TRANS/WP.29/1003
2 April 2004

**DRAFT SUPPLEMENT 7 TO THE 01 SERIES OF AMENDMENTS
TO REGULATION No. 52**

(Small capacity passenger vehicles, M2 and M3 category)

"Figure 15b

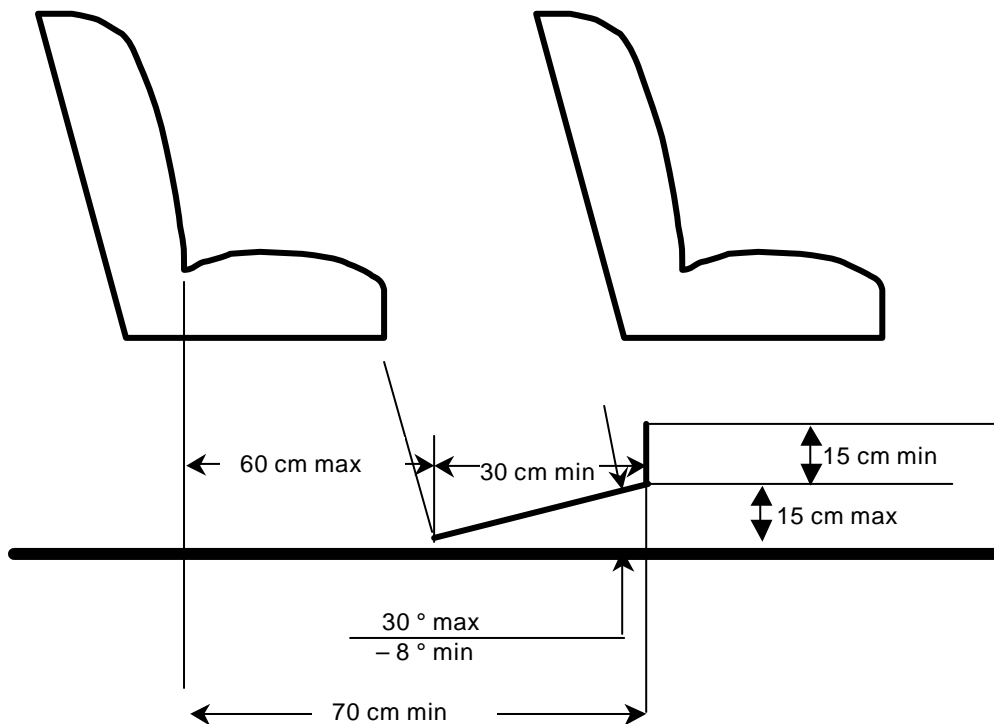
Insert a new figure 15b. to read:

"5.7.8.5.2. For a seat behind a seat and/or a seat facing the gangway, a minimum clear foot space of at least 300 mm depth and a width according to paragraph 5.7.8.2.1. shall be provided as shown in annex 3, figure 15b. The local presence in this space of seat legs and of intrusions as provided by paragraphs 5.7.8.1.3.3. and 5.7.8.1.3.4. shall be permitted provided that adequate space remains for the passengers' feet. This foot space may partly be situated in and/or above the gangway but shall not create any obstruction when measuring the minimum gangway-width in accordance with paragraph 5.7.5. Intrusion of the seat belts and seat belt anchorages shall be allowed."

'Figure 21

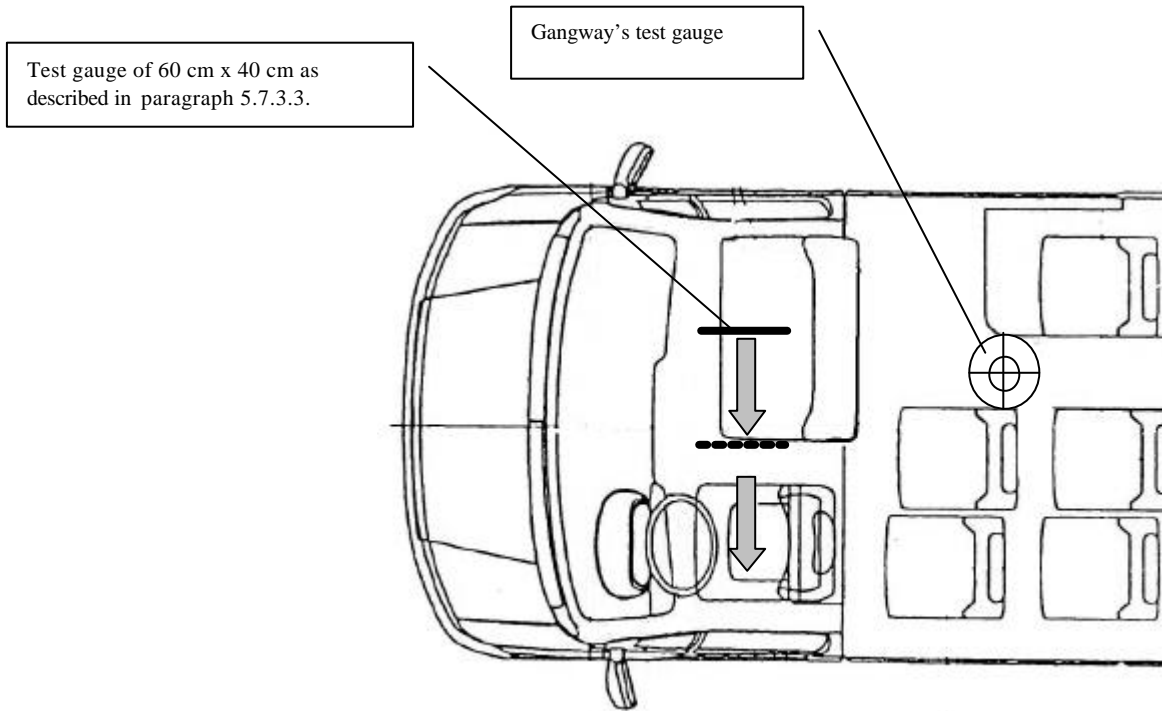
Insert new figures 21 and 22, to read:

"5.6.2.5.2. The driver's door shall be accepted as the emergency door for the occupants of the seats situated beside the driver's seat provided that it is possible to move a test gauge from the occupants' seats to the exterior of the vehicle through the driver's door (see annex 3, figure 21).

Verification of the access to the driver's door shall be subject to the requirements of paragraph 5.7.3.2., by using the test gauge having a dimension of 600x400 mm, as described in paragraph 5.7.3.3. The service door provided for the passengers shall be in the side of the vehicle opposite to that containing the driver's door and shall be accepted as the emergency door for the driver;"
